PROW comments on updated MU1 plans 2021/1090 and 1089 send to MU1@barnsley.gov.uk

Full planning permission for: earthworks to create development platforms; strategic drainage ponds/dry detention basins and associated drainage infrastructure; construction of a new link road; location of strategic landscaping and ecological areas; demolition of existing buildings; works to Hermit Lane; and erection of Phase 1(a) residential development comprising 216 dwellings,

BY00102 – Massing Plan.

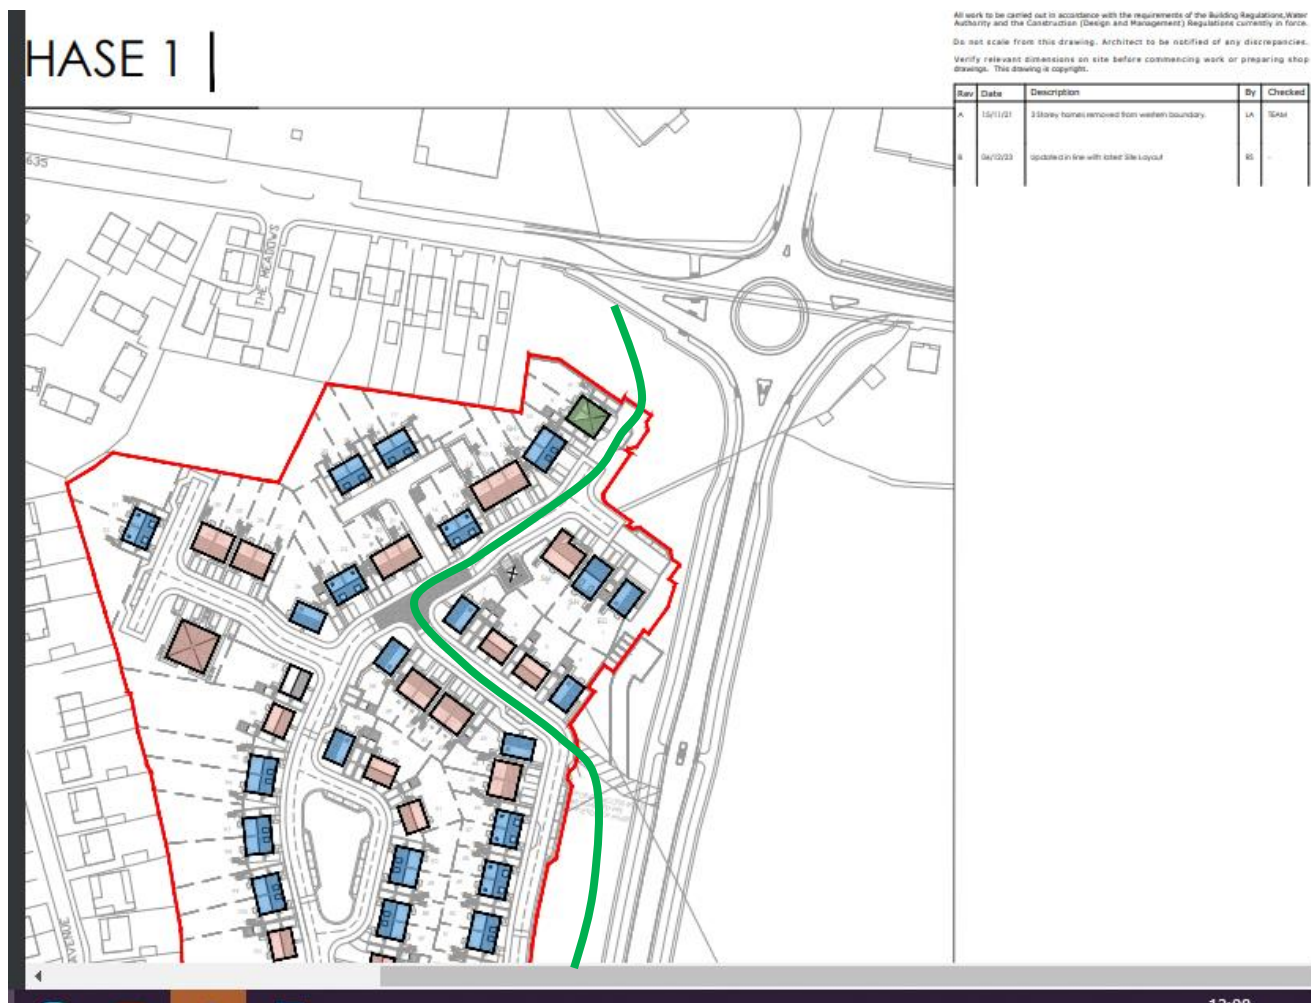
The aspiration is a bridleway corridor through route north/south through the estate. This on the masterplan this would connect into the northern housing block but there is no provision to do so within this housing layout. The housing boundary might mean there is room for the link between the road layout and housing but it is unclear.

Provision for linking into the housing and out again needs to be provided along the green line shown below
